## SOLICITATION AMENDMENT MODIFICATION DE L'INVITATION

<b>Title - Sujet</b> audio visual equipment	
<b>Solicitation No. - N° de l'invitation</b> 40021-181639/A	<b>Amendment No. - N° modif.</b> 005
<b>Client Reference No. - N° de référence du client</b> 40021-181639	<b>Date</b> 2019-01-04
<b>GETS Reference No. - N° de référence de SEAG</b> PW-\$\$HN-331-75923	
<b>File No. - N° de dossier</b> hn331.40021-181639	<b>CCC No./N° CCC - FMS No./N° VME</b>
<b>Solicitation Closes - L'invitation prend fin</b> <b>at - à 02:00 PM</b> <b>on - le 2019-01-21</b>	<b>Time Zone</b> <b>Fuseau horaire</b> Eastern Standard Time EST
<b>F.O.B. - F.A.B.</b> <b>Plant-Usine:</b> <input type="checkbox"/> <b>Destination:</b> <input checked="" type="checkbox"/> <b>Other-Autre:</b> <input type="checkbox"/>	
<b>Address Enquiries to: - Adresser toutes questions à:</b> Turner, Louie	<b>Buyer Id - Id de l'acheteur</b> hn331
<b>Telephone No. - N° de téléphone</b> (613) 297-3769 ( )	<b>FAX No. - N° de FAX</b> ( ) -

Amendment #5 is issued to answer site visit and potential bidder's questions. Also attached are four IT drawings that show cable tray locations as well as the drawings with the new room numbers

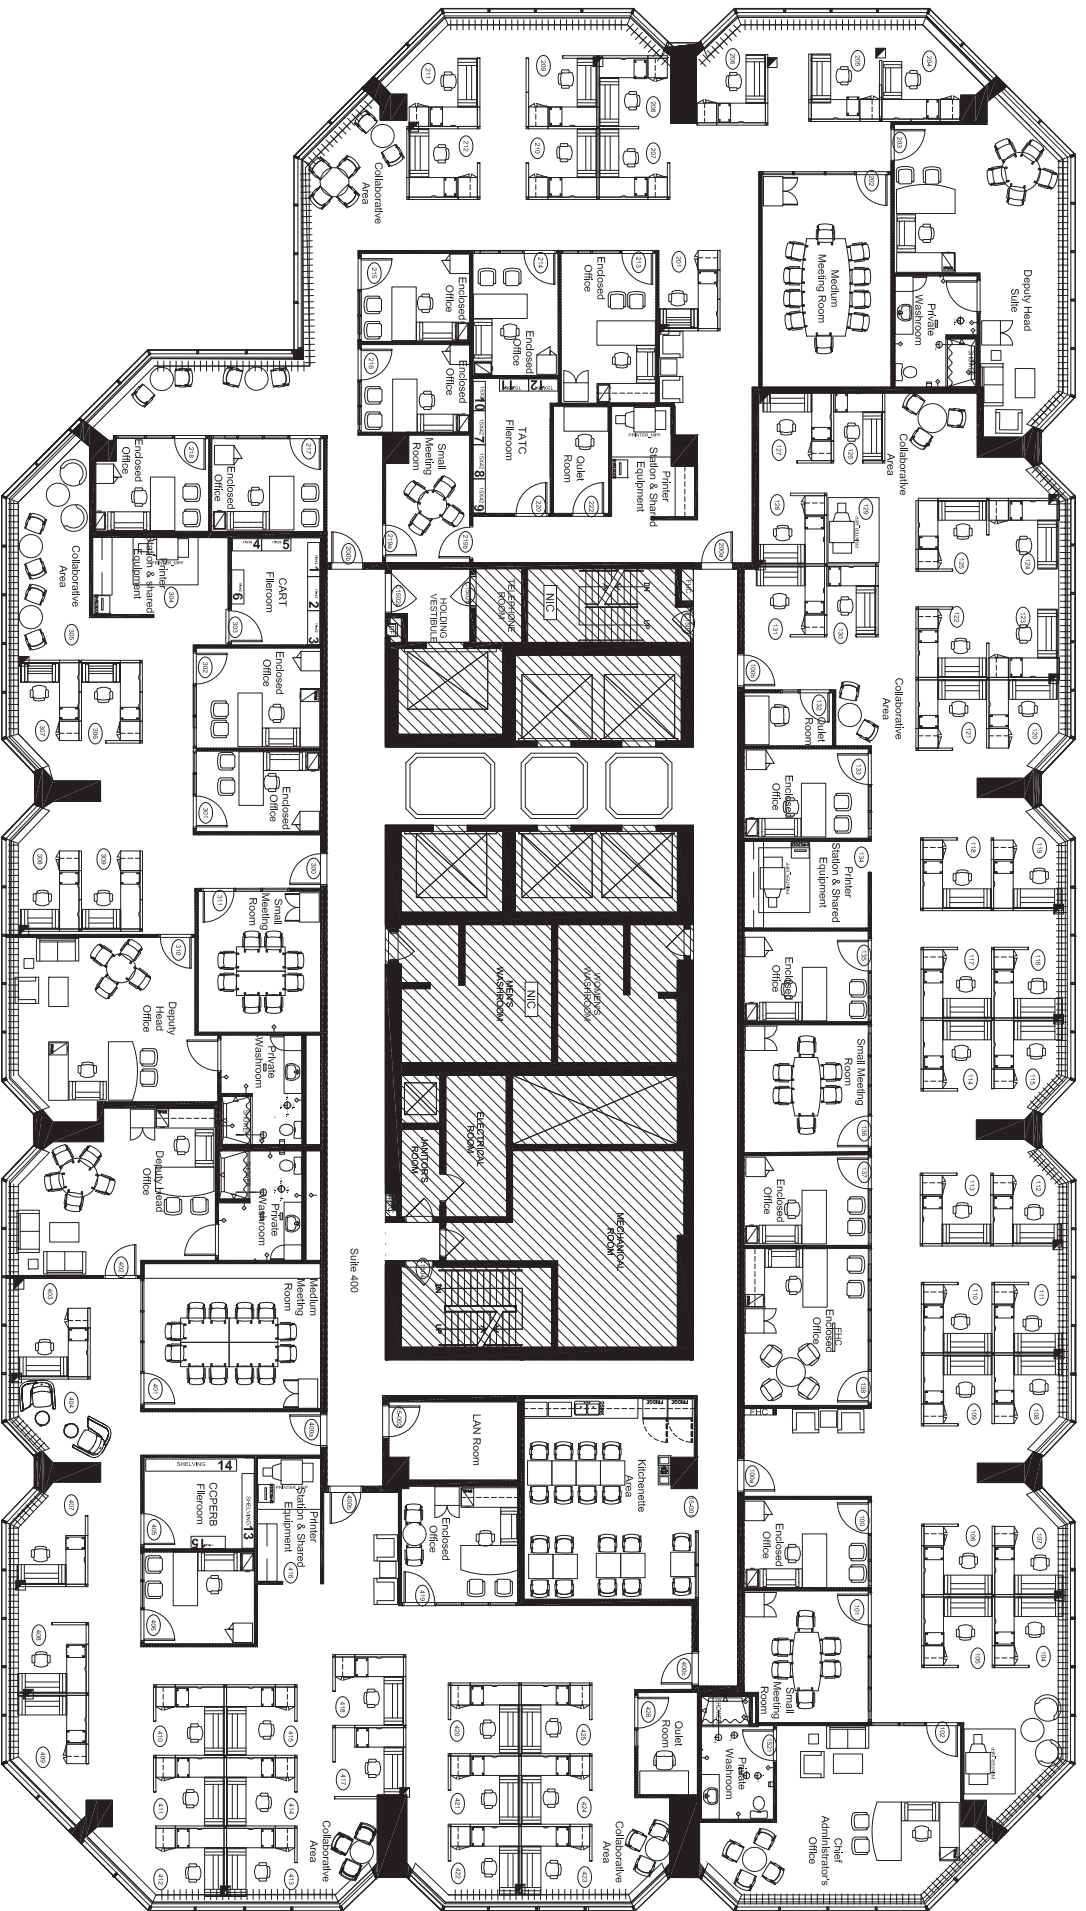
"In their technical bid, Bidders should explain and demonstrate how they propose to meet the requirements and how they will carry out the Work.

The Contractor must provide all system engineering and design necessary to develop the complete systems described herein. Engineering and design must include preparation of all electronic schematics, hardware drawings, systems diagrams, schedules and lists as per Contract Data Requirements List (CDRL). These documents must be provided in soft copy (E-post, CD, DVD or USB key) at the time of bid.

From the excerpt above, it is clear what the winning "Contractor" has to provide as part of a contract, however, what is a bidder expected to provide to comply with this section?"

This is a delivery requirement, only the winning bidder has to deliver this.
